YANG module ieee802-dot1dj-tsn-config-uni

This contribution details multiple **ballot comments** and their respective **proposed changes** regarding the YANG module `ieee802-dot1dj-tsn-config-uni`

Issue b)

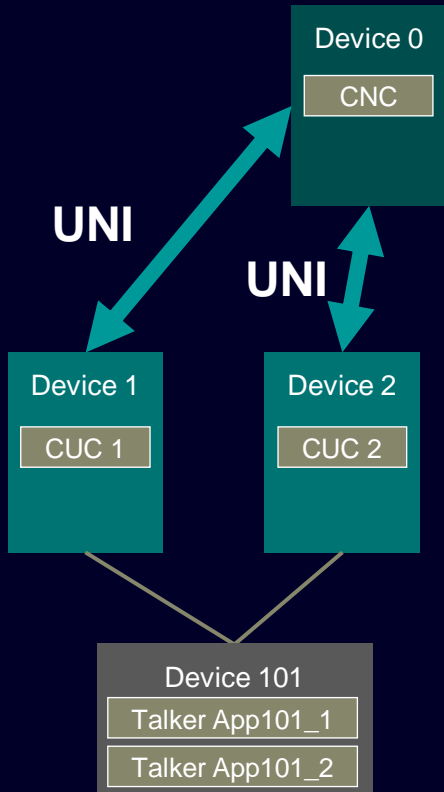
Duplicated StreamID assignment

StreamIDs must be
centrally managed, i.e.
assigned by the CNC

Issue c)

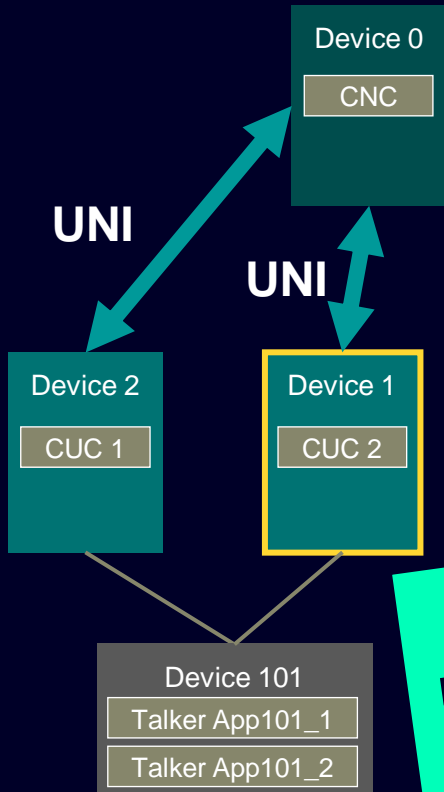
! Duplicated StreamID assignment

15 **46.2.5.3.1 IEEE802-MacAddresses**

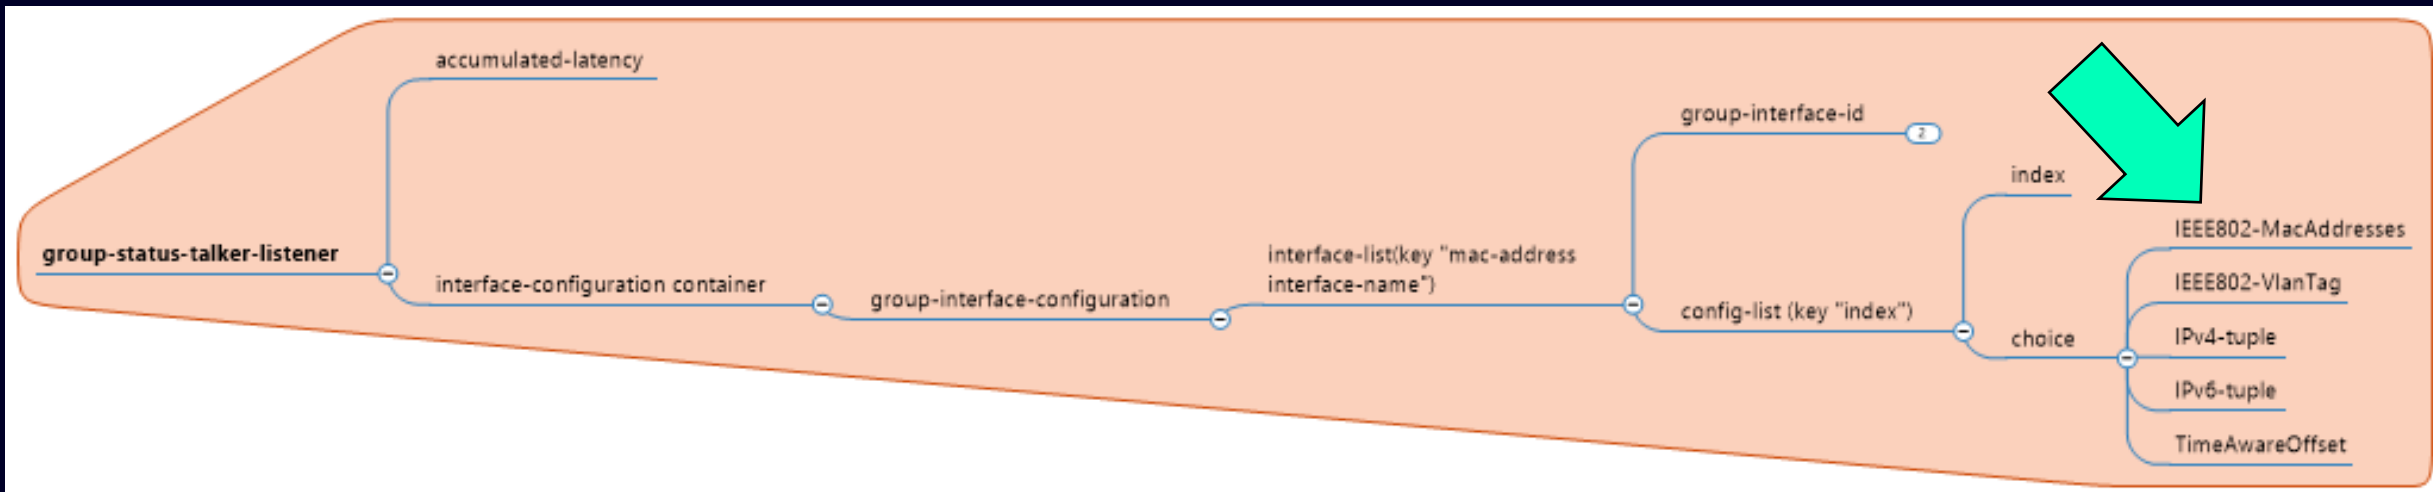
This restriction must be removed from the standard
